McKinley High School – Construction Documents
800 E McKinley St, Baton Rouge, LA 70802
Domain Chasm Project No. C24-0038/24009

ADDENDUM NO. 2

A8.712

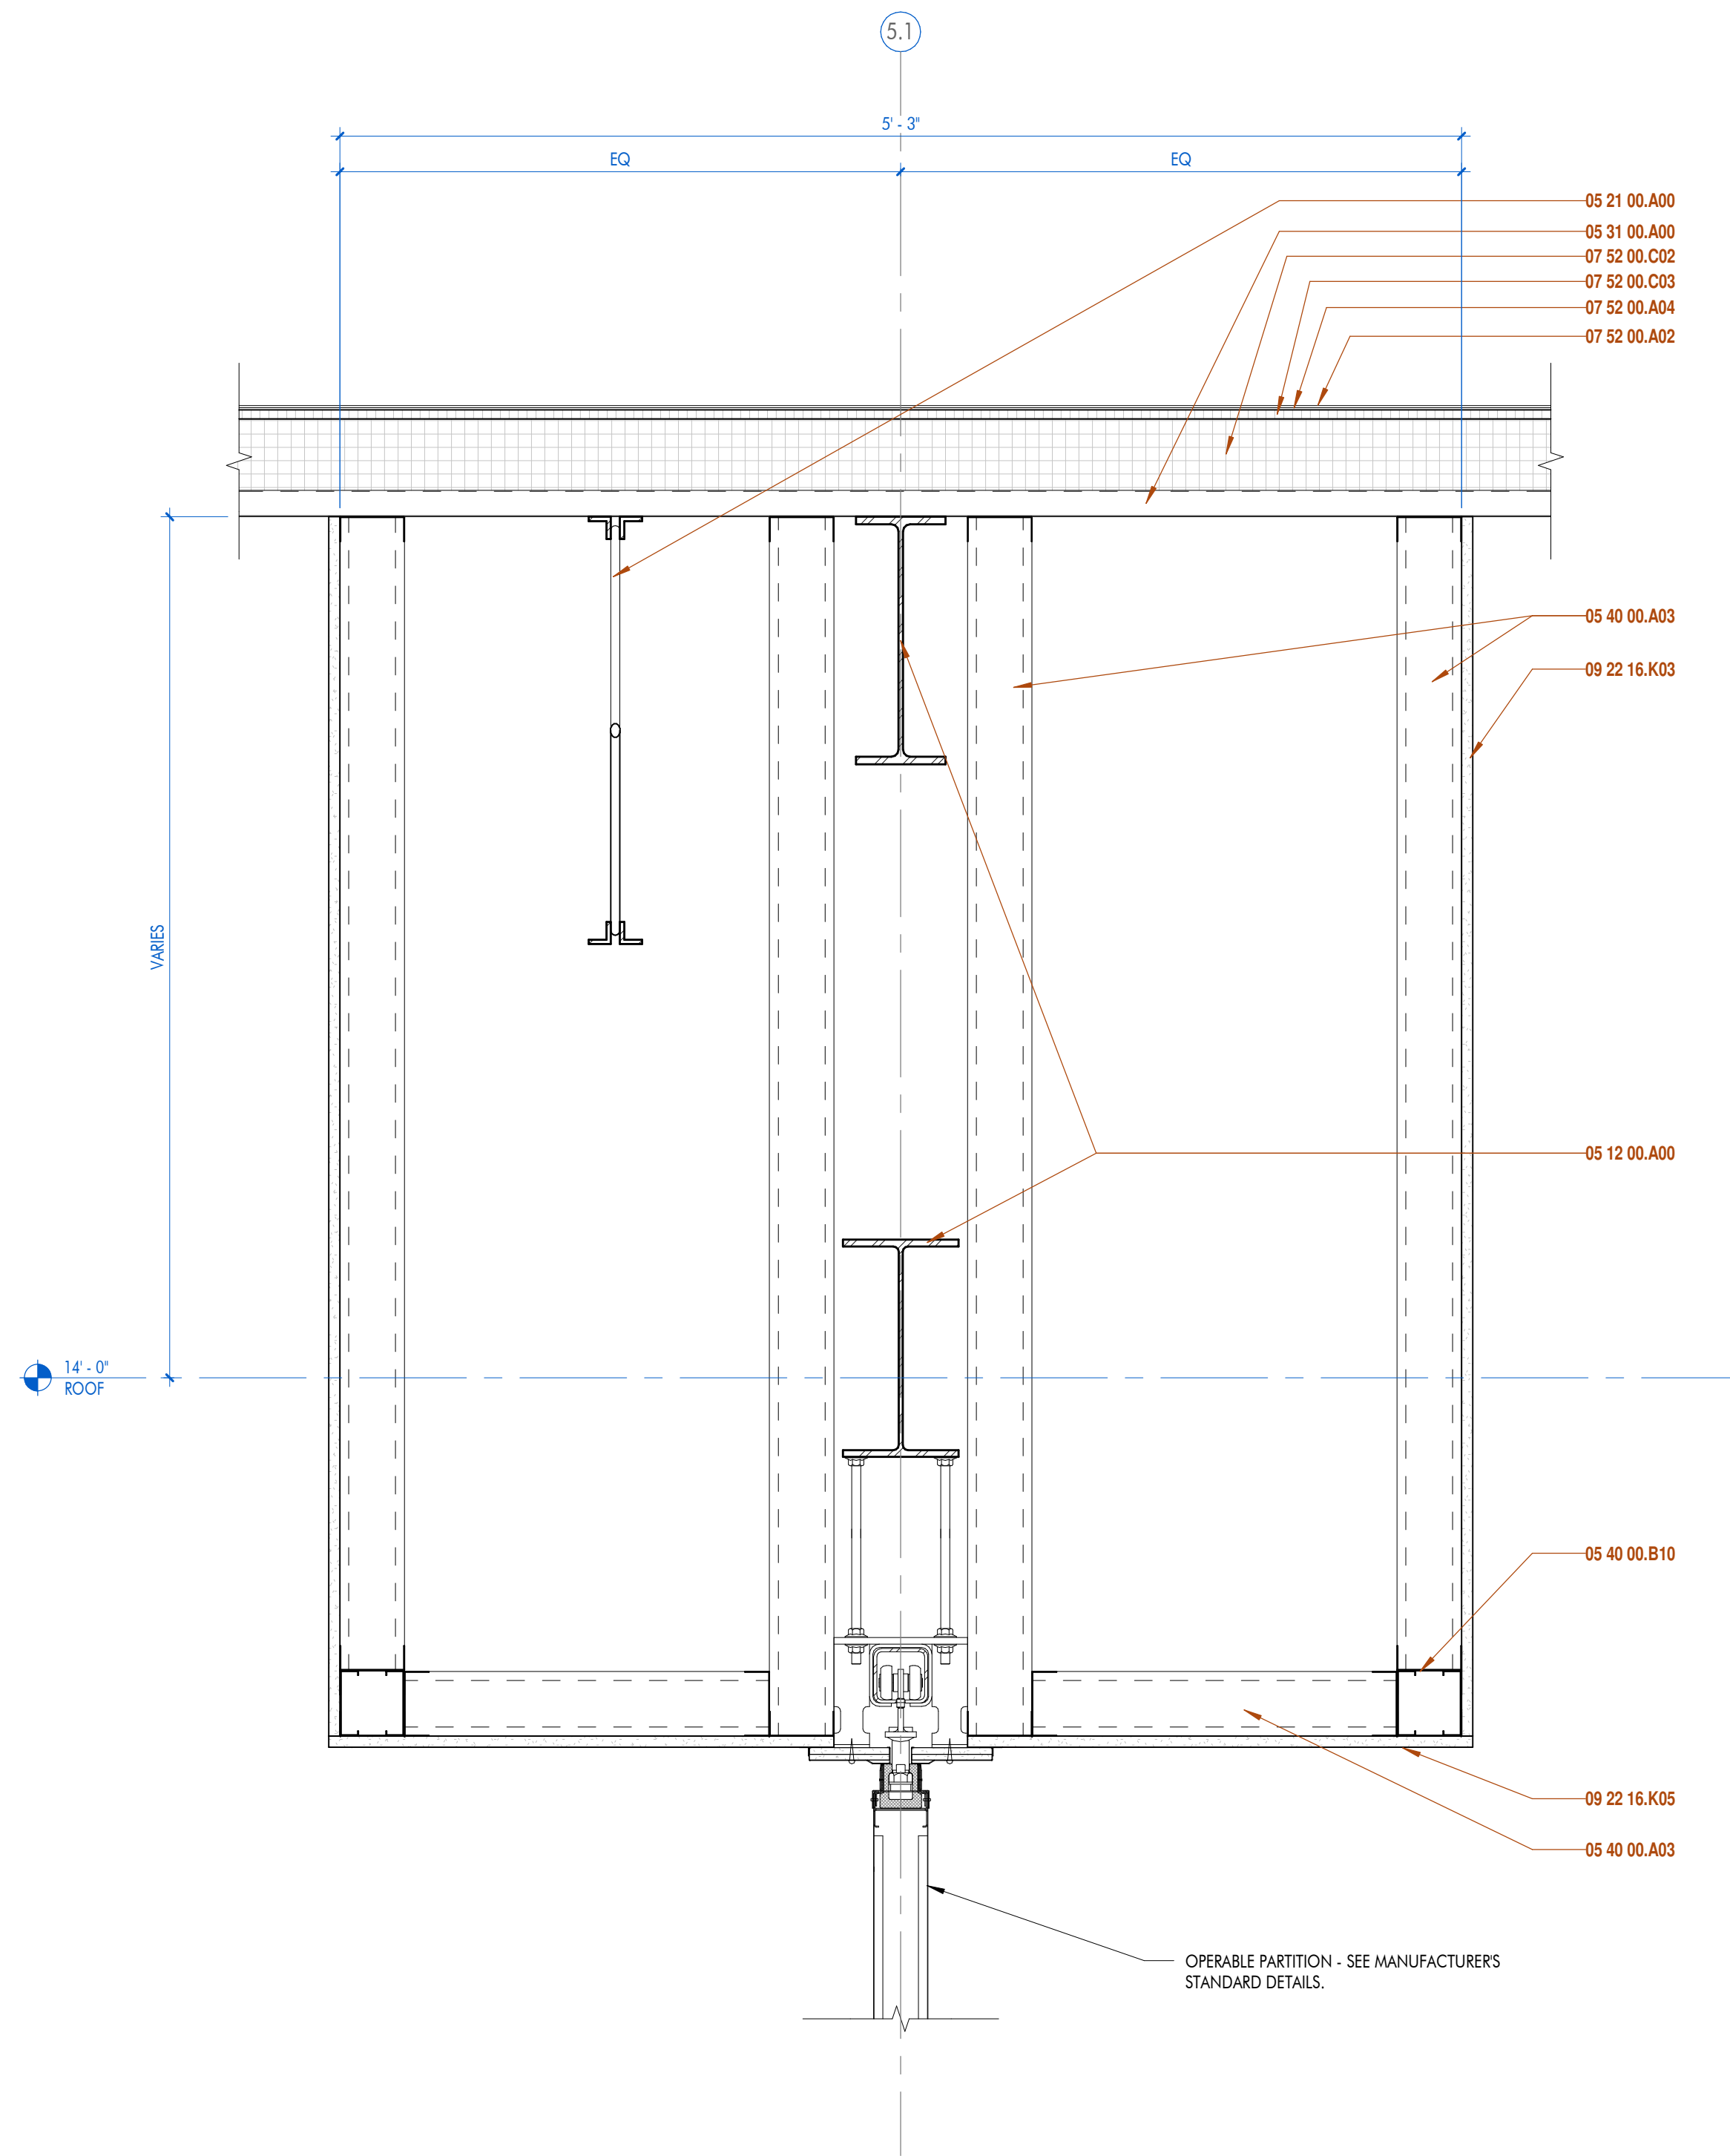
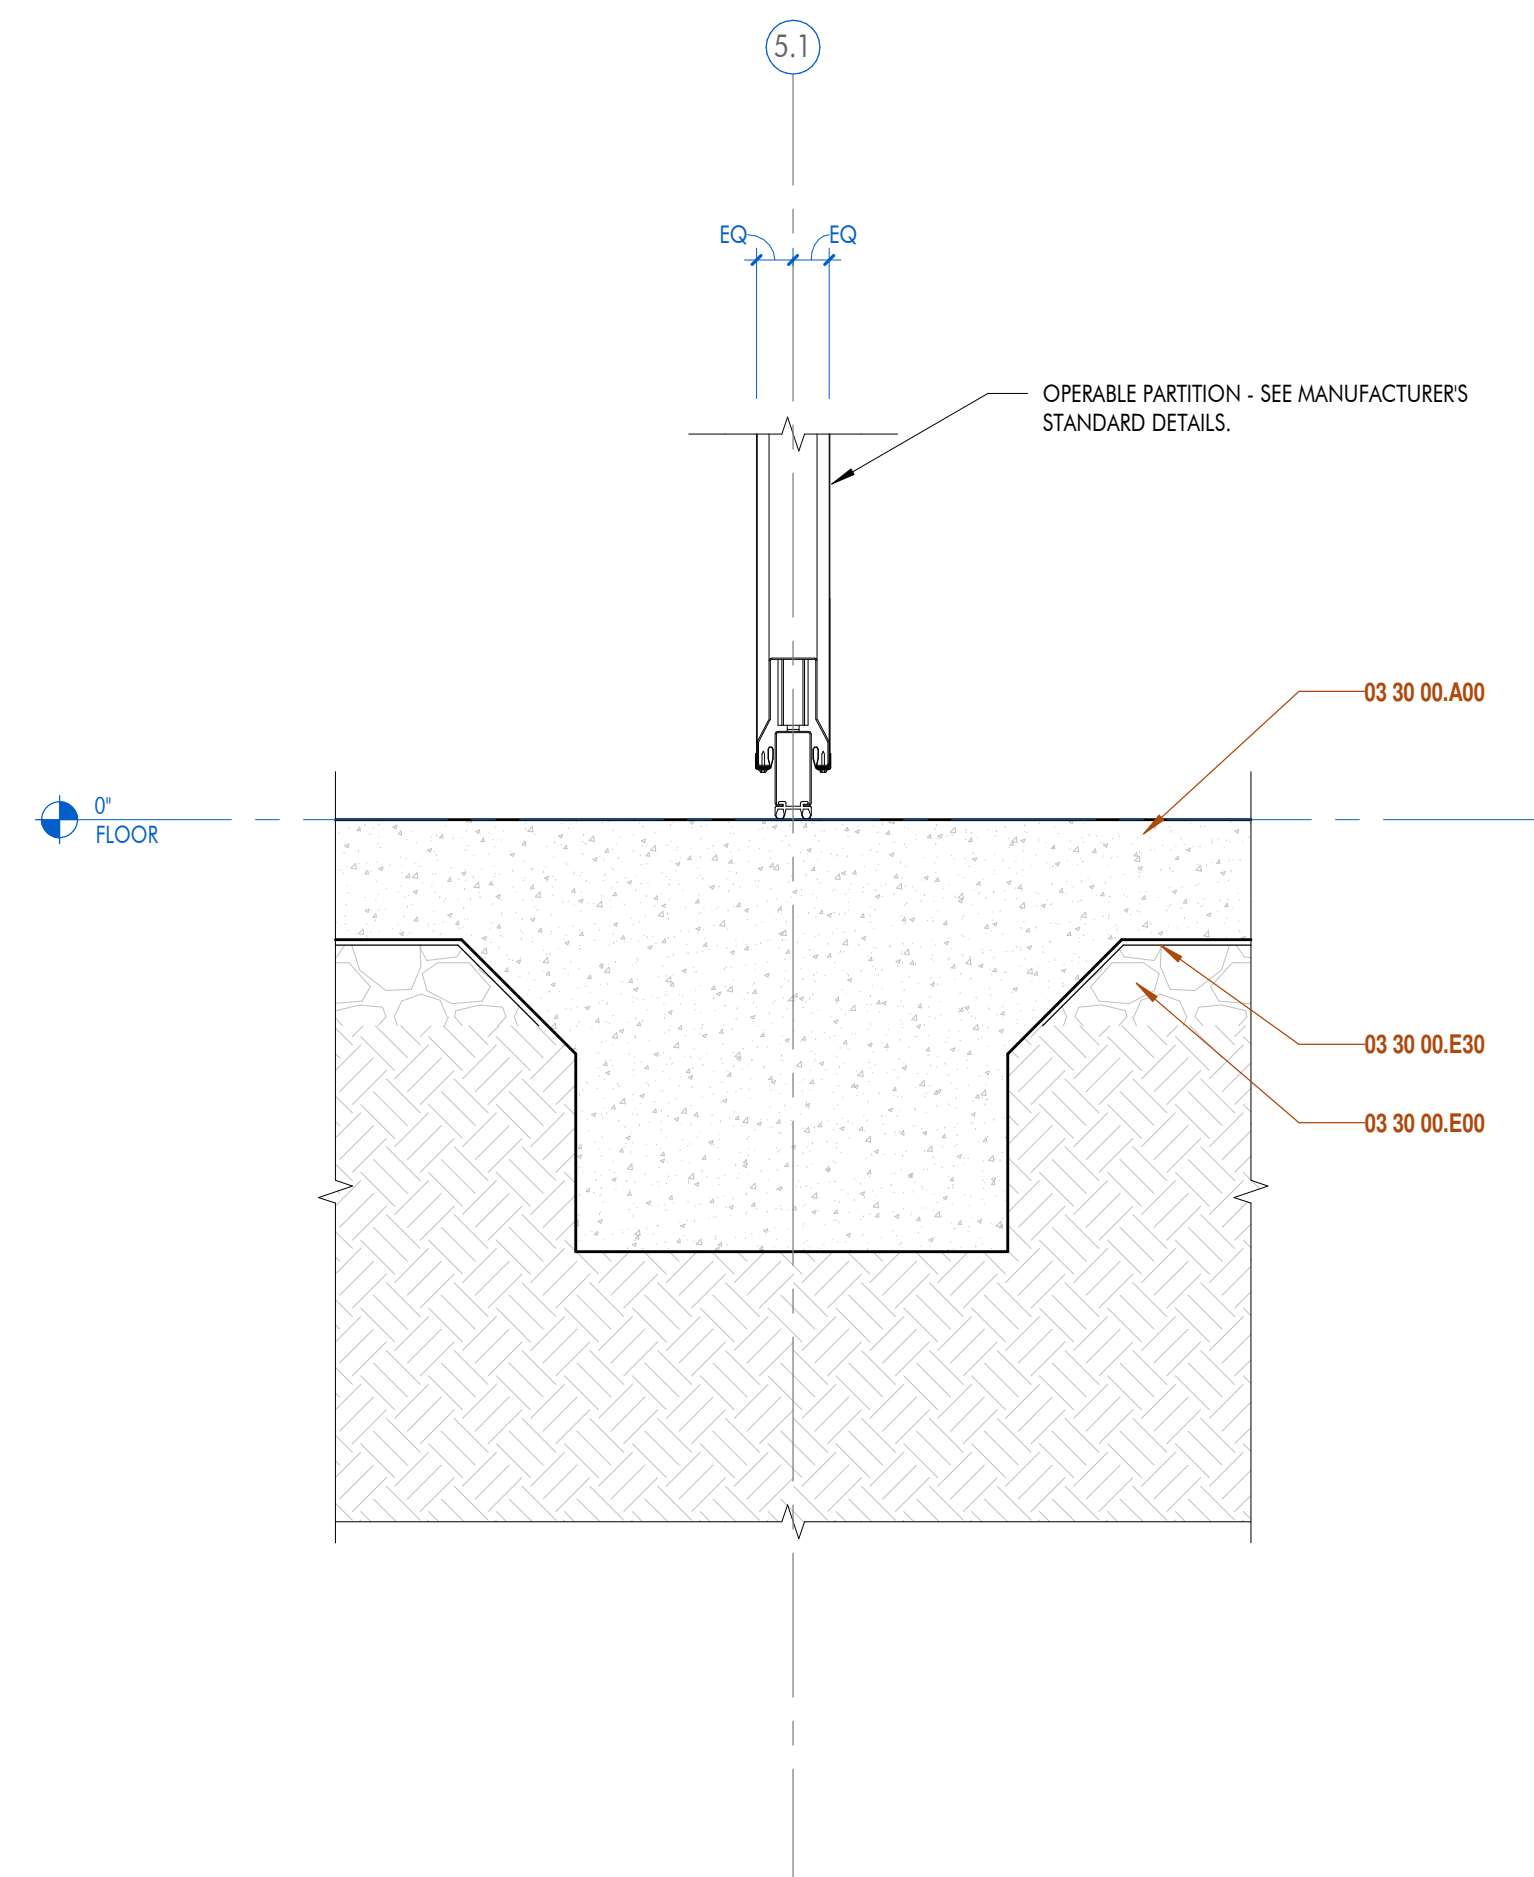
15. Sheet A8.712 - Section Details – New Arts Bldg. - Remove previously issued sheet and replace sheet with revised attached sheet.
 - a. Detail 3/A8.712 Section Detail – Added keynotes to detail.
